PROPOSED TECHNICAL SPECIFICATION CHANGE

SEQUOYAH NUCLEAR PLANT UNITS 1 AND 2

(TVA-SQN-TS-89-26)

Description of Change

Figure 15.4.2-4 Transient Response to Steam Line Break Downstream of Flow, Measuring Nozzle with Safety Injection and Without Off-Site Power (case c)

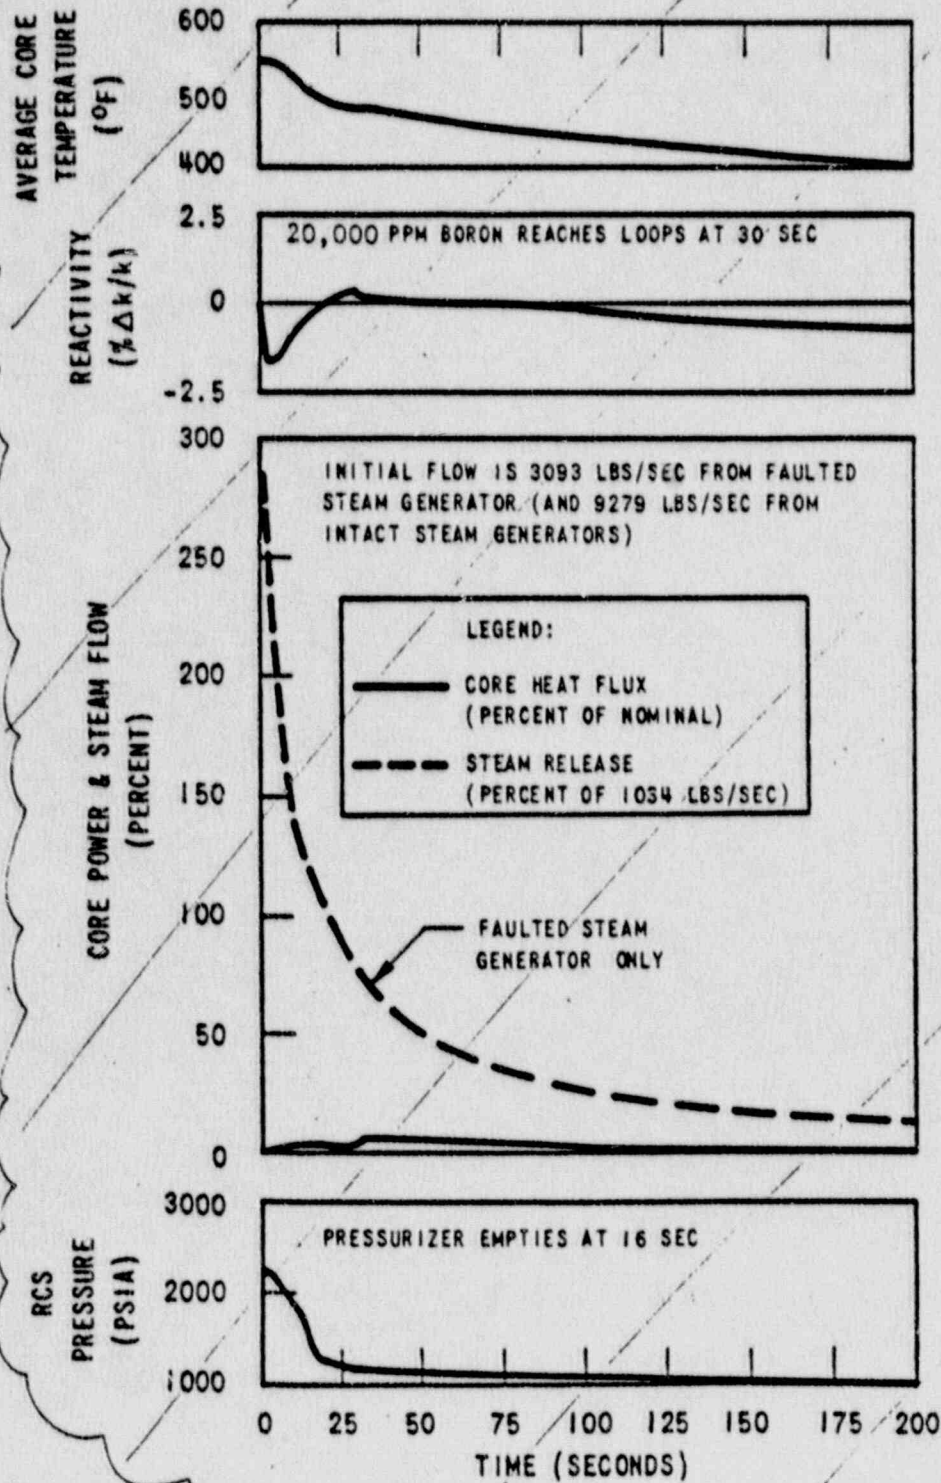
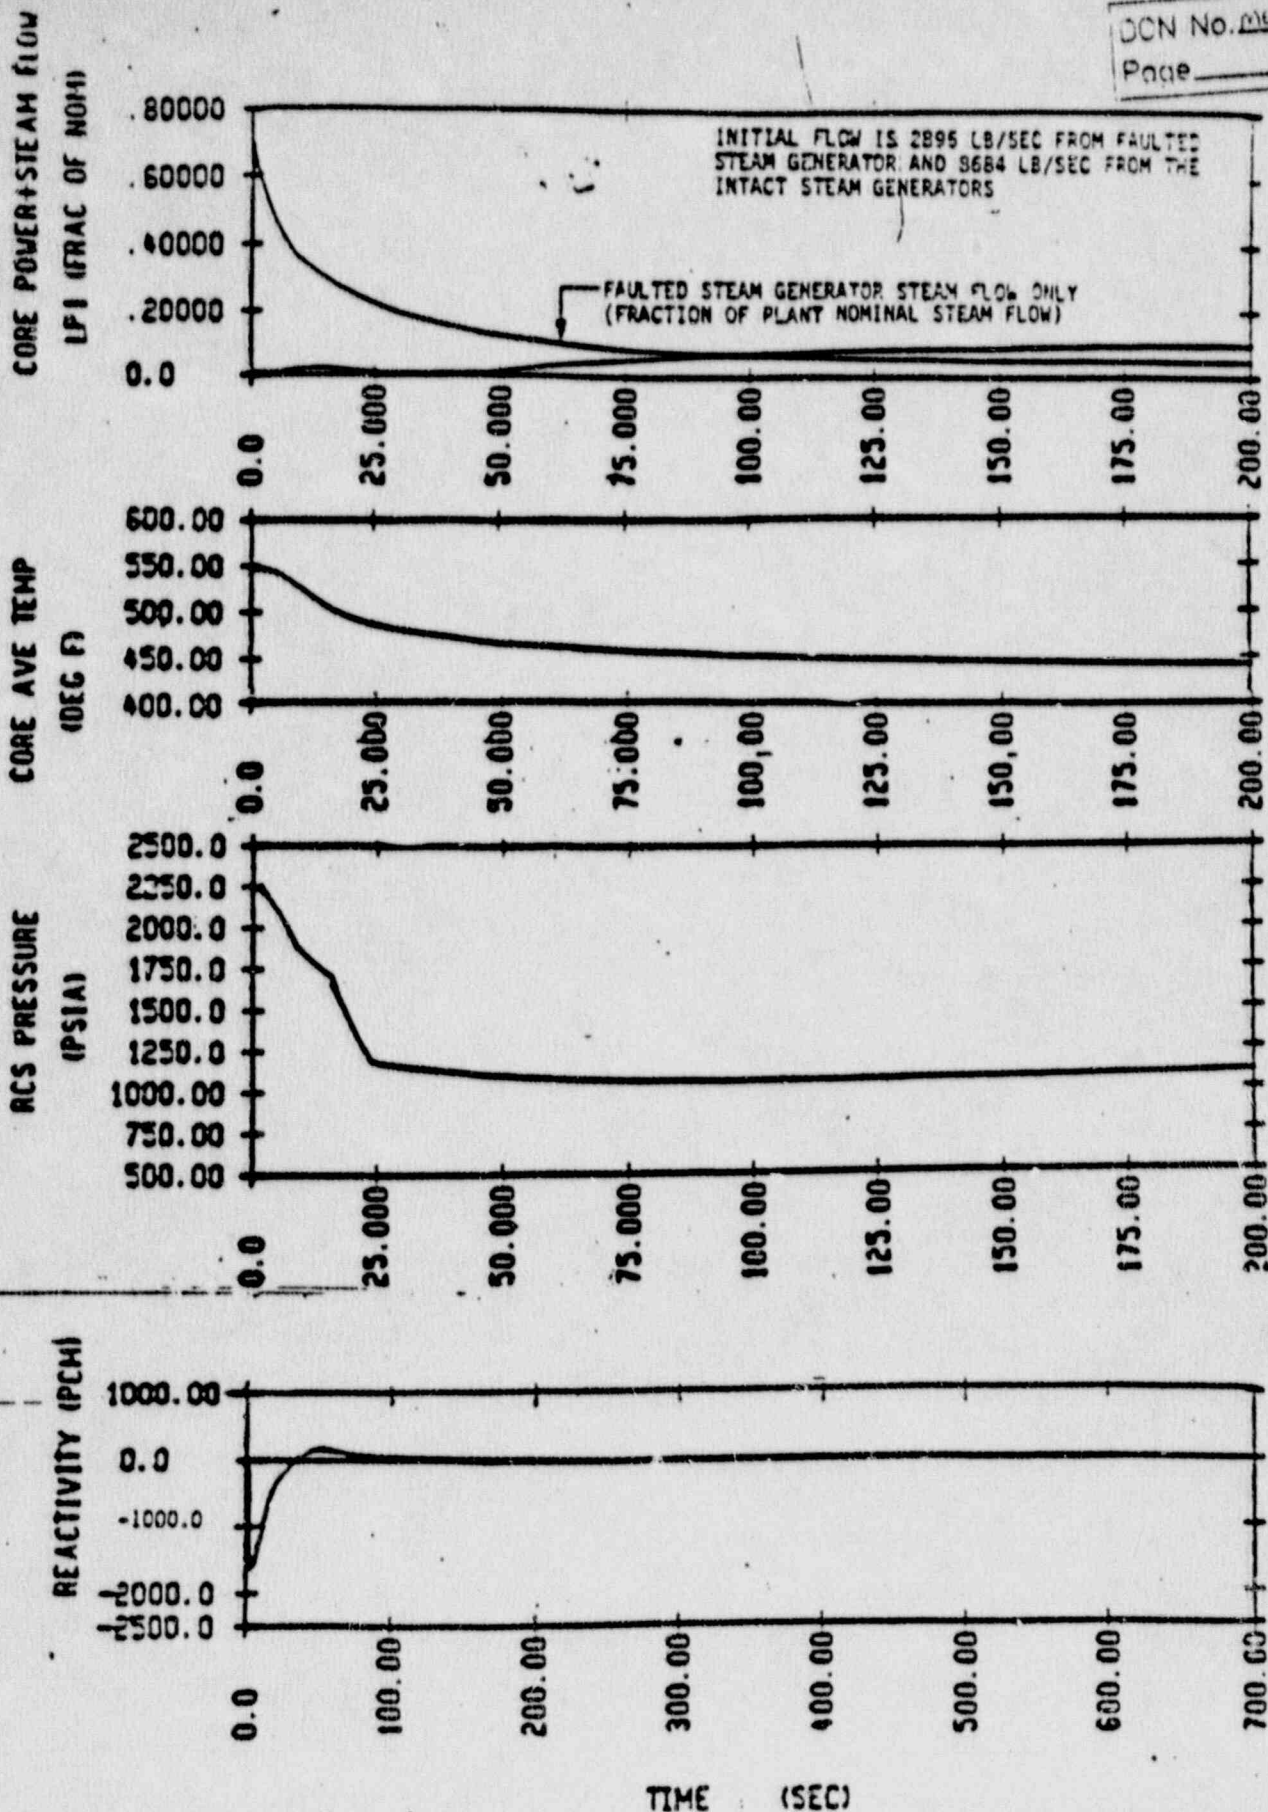
Figures 15.4.2-4 and 15.4.2-5 show the responses of the salient parameters for cases c and d respectively which correspond to the cases discussed above with additional loss of offsite power at the time the safety injection signal is generated. The Safety Injection System delay time includes 12 seconds to start the emergency diesel generator and 12 seconds to get the safety injection pump to full speed. In each case criticality is achieved later and the core power increase is slower than in the similar case with offsite power available. The ability of the emptying steam generator to extract heat from the RCS is reduced by the decreased flow in the RCS. For both these cases the peak core power remains well below the nominal full power value.

Figure 15.4.2-5 Transient Response to Steam Line Break at Exit of Steam Generator with Safety Injection and Without Off-Site Power (case d)

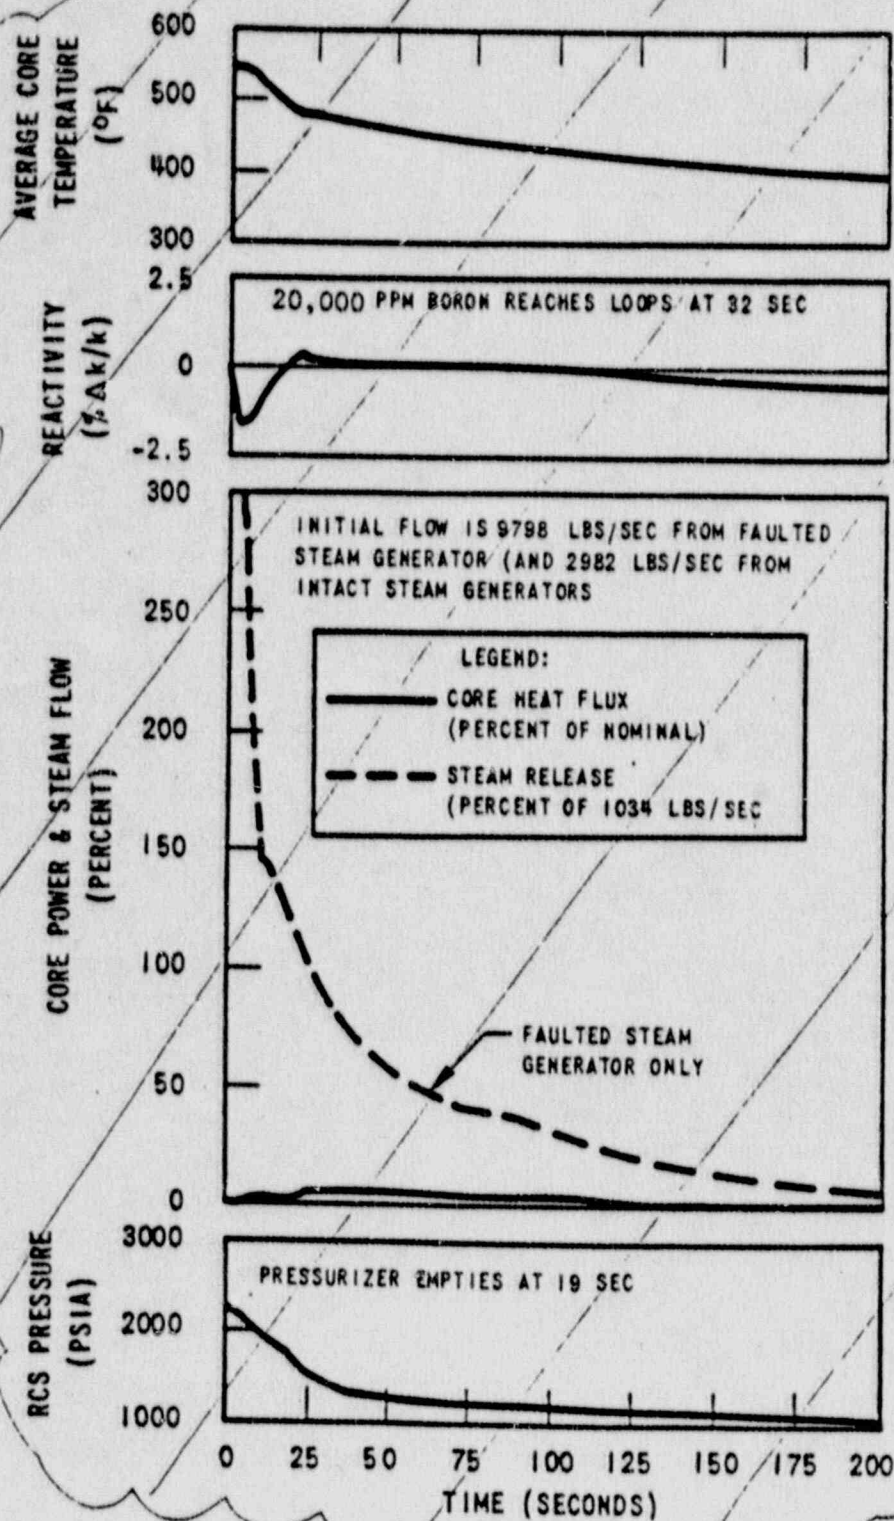
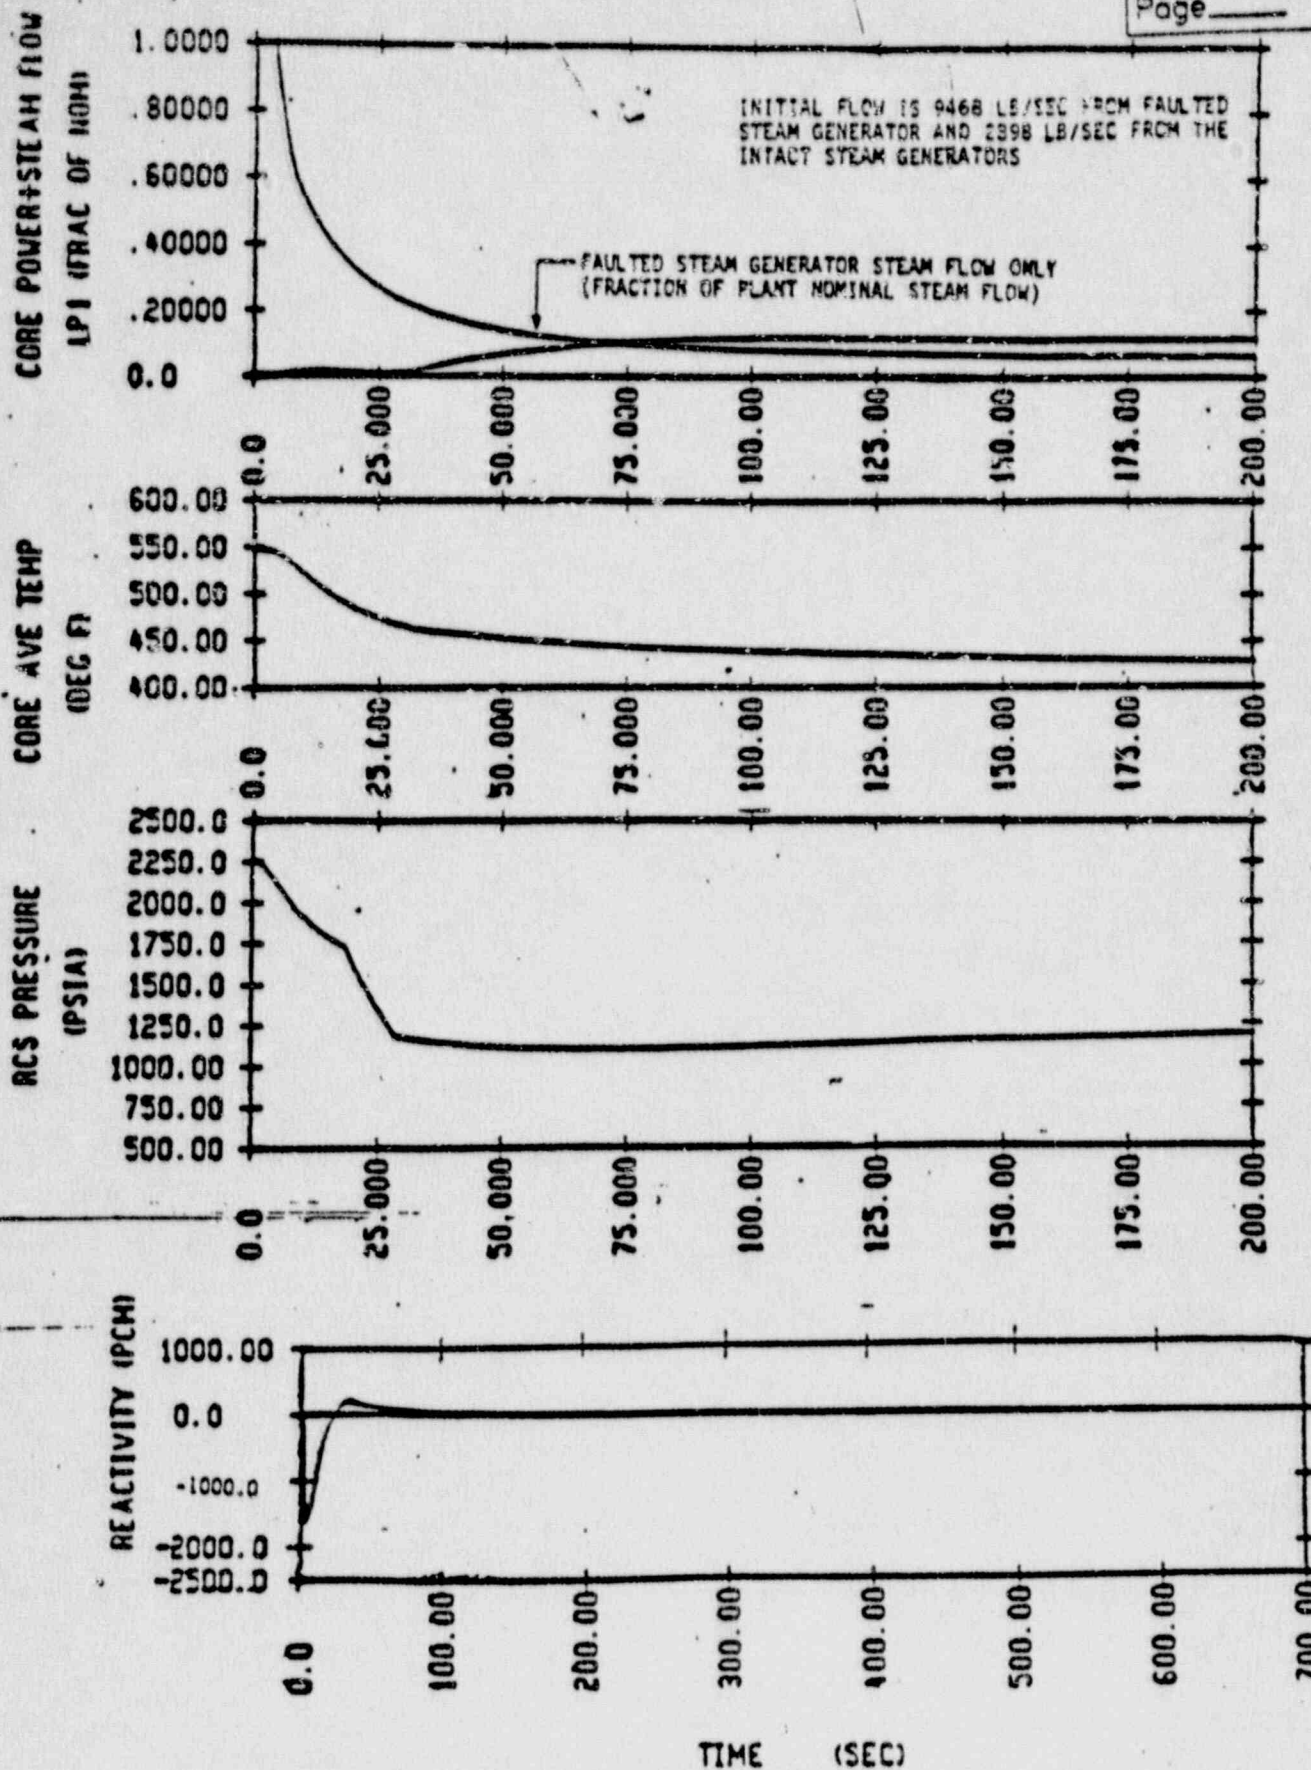
Delete
and Replace

Figure 15.4.2-7 Integrated Flow of Borated Water versus Time

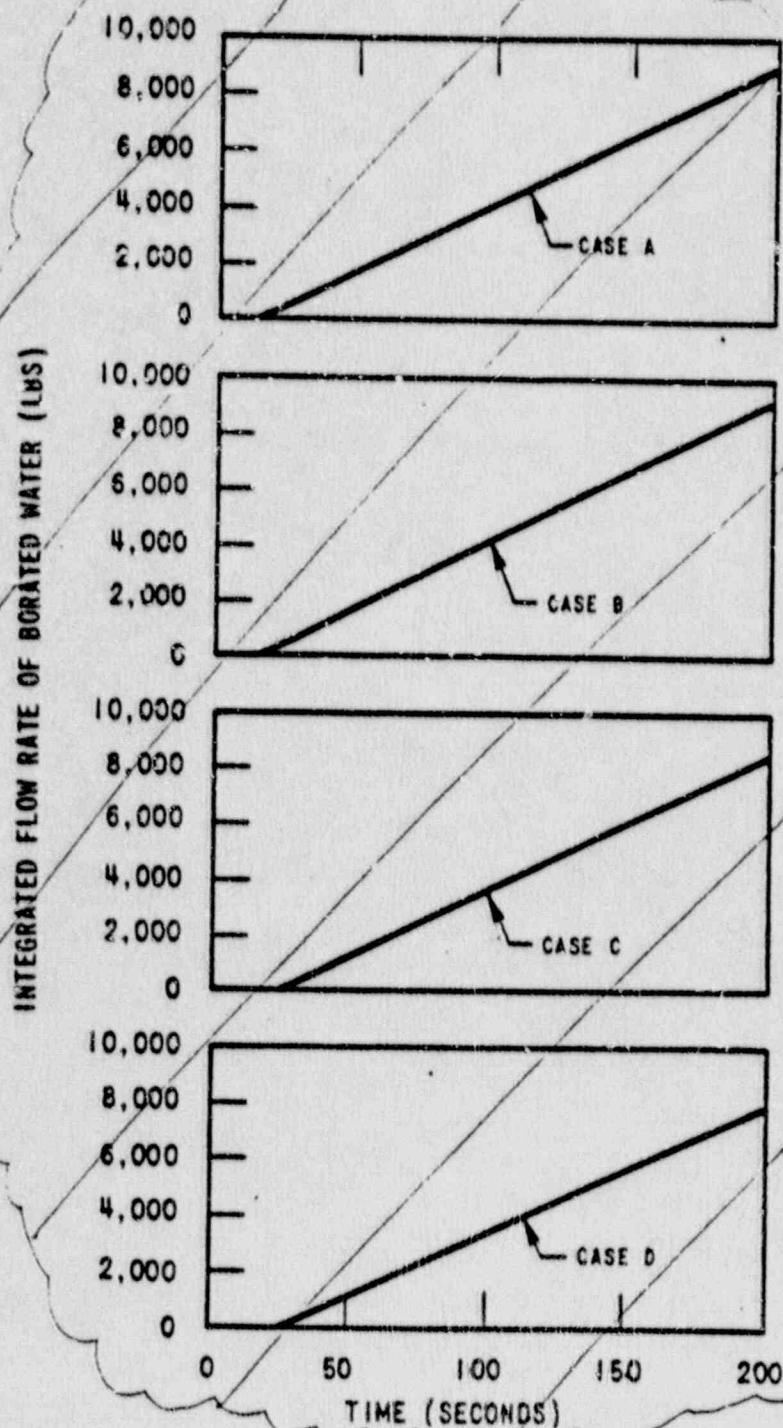
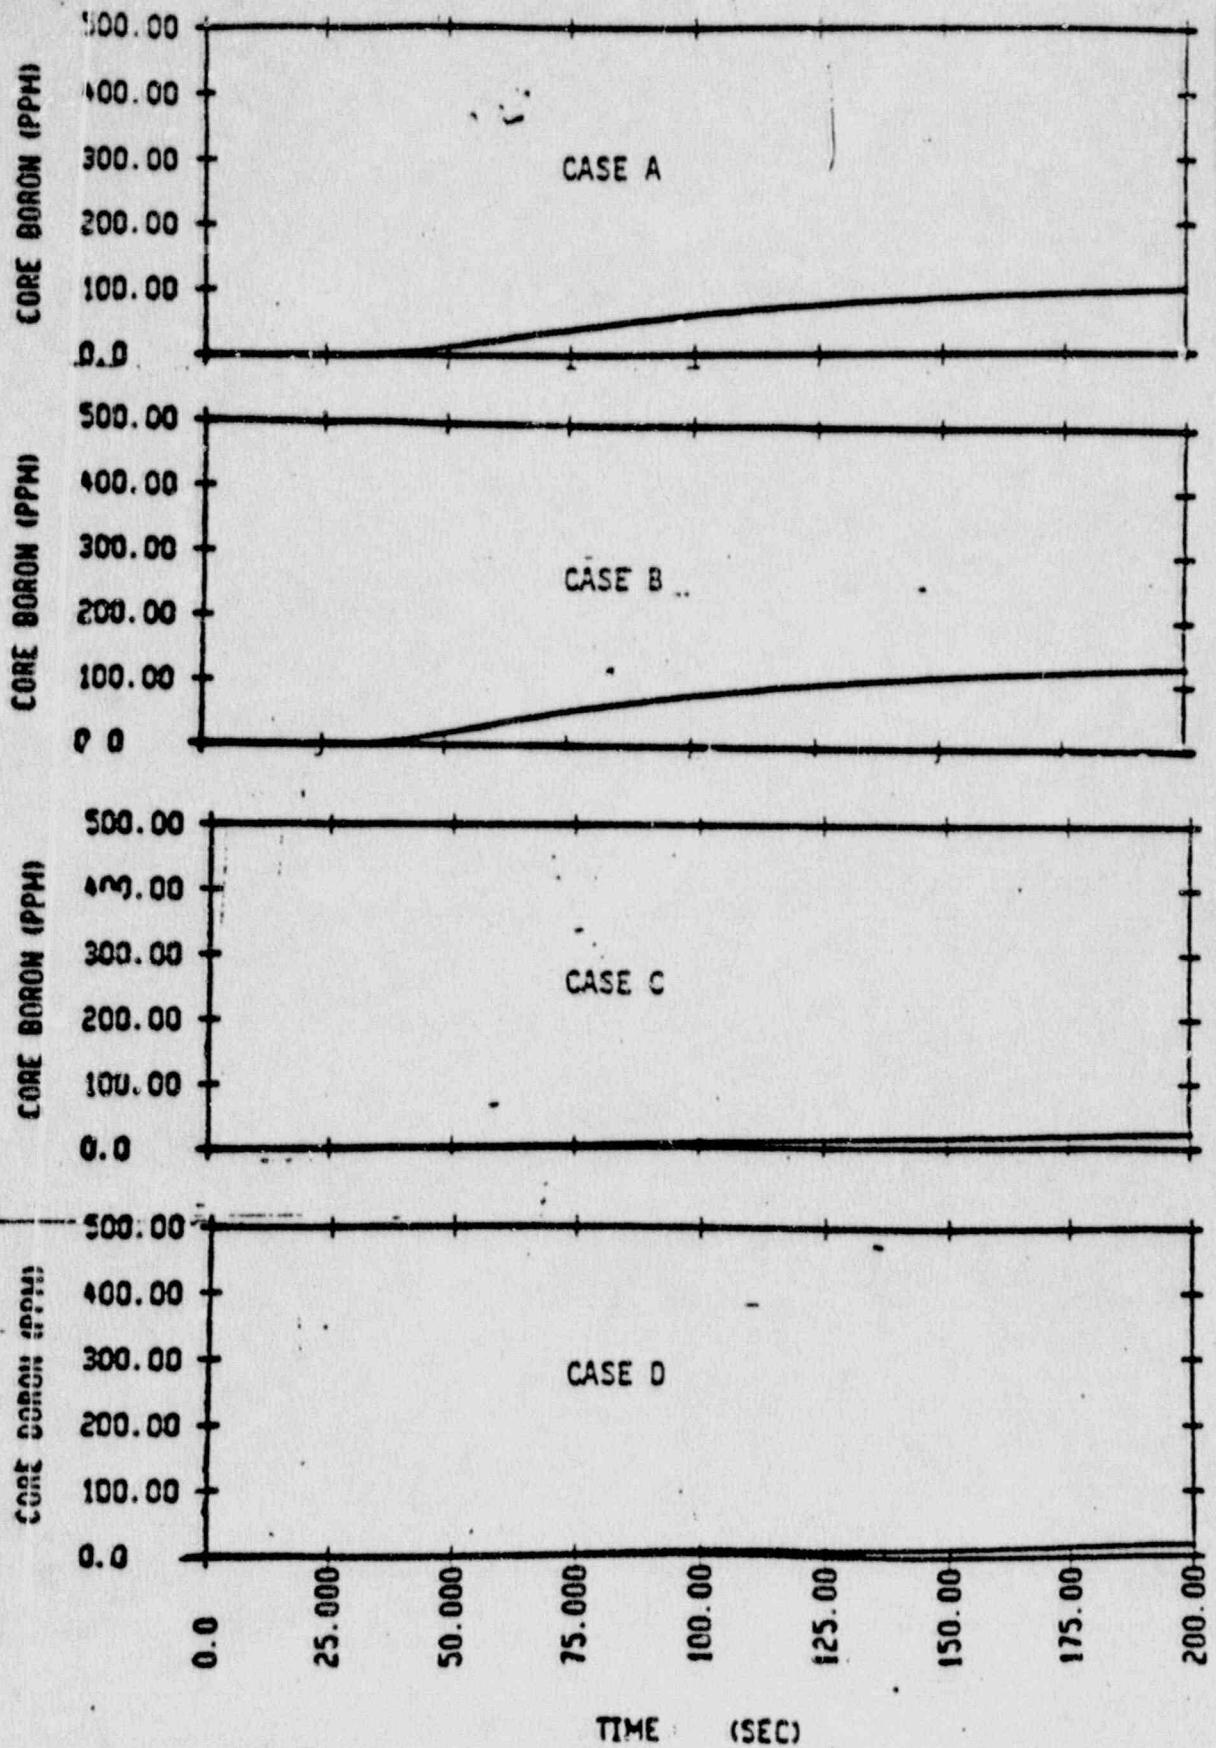
The accumulators provide an additional source of borated water after the RCS pressure decreases to below 447 psia. The integrated flow rate of borated water from the Safety Injection system for each of the four cases analyzed is shown in Figure 15.4.2-7. * core boron concentration

Delete
and Replace
